**SOLICITATION AMENDMENT  
RFP(LPTA) #2019019  
CITY OF BUCKEYE  
CONSTRUCTION & CONTRACTING DIVISION**

**AMENDMENT #1**

**SOLICITATION: RFP# 2019019: FIRE STATION #705 TARTESSO**

**RFP(LPTA)# 2019019: FIRE STATION #705 TARTESSO**  
**AMENDMENT NUMBER 1**  
**AMENDMENT ISSUE DATE: September 30, 2019**

Job Number: 19024	Sketch Number: ESK SEP18-01	Reference Drawing: E5.1
Date: 09/18/19		Scale: NTS

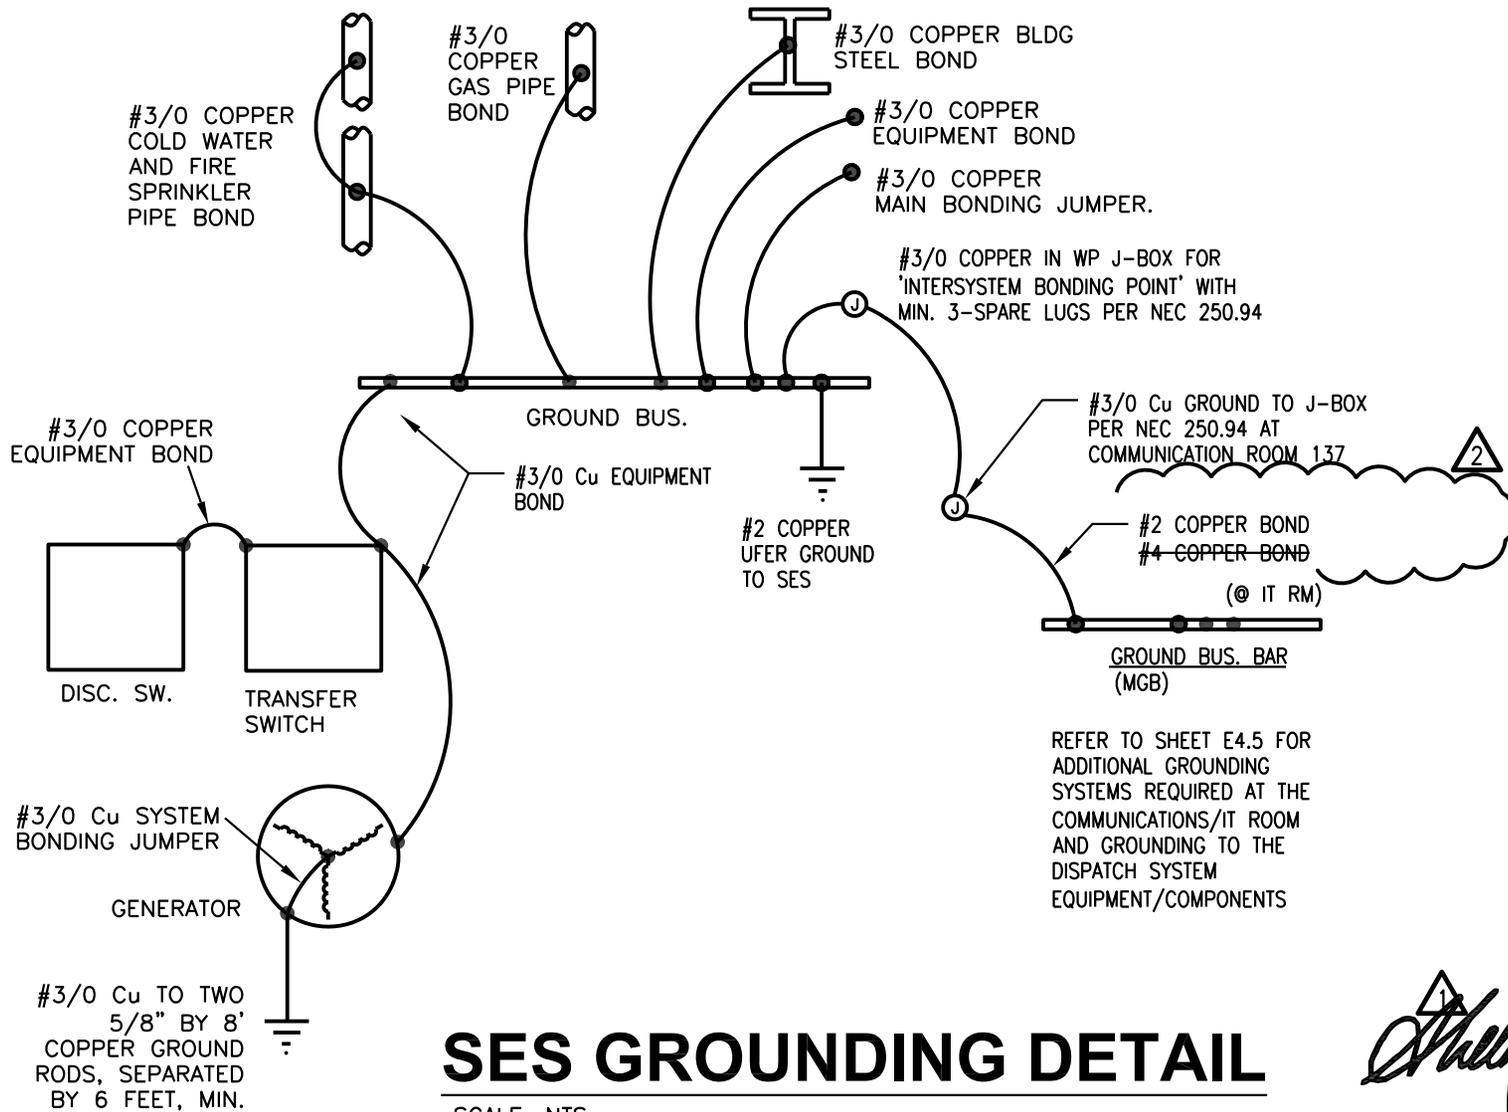
- a. Reference Sheet E4.1 and E4.2
  - i. Sheets E4.1 and E4.2 were replaced by “Updated Alerting” E4.1 & E4.2 Provided on [www.buckeyeaz.gov/open-soicitations](http://www.buckeyeaz.gov/open-soicitations)
- b. Reference Sheet E5.1 SES Grounding Detail
  - i. SES Grounding Detail Modification- see attached Sketch “ESK SEP 18-01”
- c. Reference Sheet E5.2 Panel Schedules
  - i. Panel Schedule Modifications- see attached Sketches “ESK SEP 10-01” & “ESK SEP 10-02”

REFER TO SHEET E4.5 FOR ADDITIONAL GROUNDING SYSTEMS REQUIRED AT THE COMMUNICATIONS/IT ROOM AND GROUNDING TO THE DISPATCH SYSTEM EQUIPMENT/COMPONENTS

# SES GROUNDING DETAIL
